NL-14-109

**SUBJECT:** Indian Point Energy Center's Third Six-Month Status Report for the Implementation of Order EA-12-051 Modifying Licenses with Regard to Requirements for to Reliable Spent Fuel Pool Instrumentation (TAC Nos. MF0737 and MF0738)  
Indian Point Unit Numbers 2 and 3  
Docket Nos. 50-247 and 50-286  
License Nos. DPR-26 and DPR-64

ENTERGY'S THIRD SIX-MONTH  
STATUS REPORT FOR THE  
IMPLEMENTATION OF ORDER EA-12-051 MODIFYING LICENSES  
WITH REGARD TO REQUIREMENTS FOR RELIABLE SPENT  
FUEL POOL INSTRUMENTATION

**Figure 1: IP3 SFPI Fan House Cable Routing**

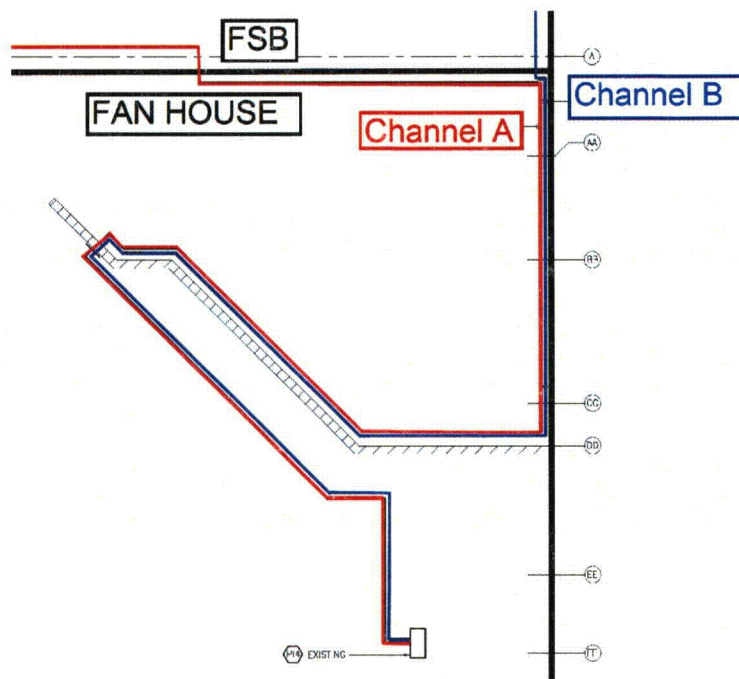
**Please provide a description of the protection provided for the cabling routed along the exterior of the fuel building for Channel B of IP2 and IP3. Also, please provide a sketch to illustrate the remaining cable routing from the fuel building wall penetrations to the processor units for Channel A and Channel B for IP2 and IP3.**

For IP3, Channel A will penetrate through the west wall into the Fan House approximately 30 ft north of the doorway into the Fan House. The Fan House is a Seismic Class 1 structure that is protected against adverse weather conditions. The Channel B route will follow the east wall to the south wall, follow along the south wall and penetrate on the south side of the doorway between the Fan House and the Fuel Storage Building (FSB). Once outside the FSB, the two conduit runs will converge near the door between the FSB and the Fan House. Each channel will maintain plant design channelization requirements by remaining in their dedicated conduits. The two channels will be run down to the 67'-6" Elevation of the PAB Fan House. Both conduits are to be routed through the existing penetration south of the door between the Fan House and the upper mezzanine of the pipe penetration area. Once through the penetration they will be routed down the hall to the Gas Analyzer Rack, which is part of the retired in place Hydrogen Recombiner Panel. The two indicators will be mounted on the panel by removing the retired in place equipment and installing the level indicators. The IP3 SFPI cable routing within the Fan House is shown graphically in Figure 1.
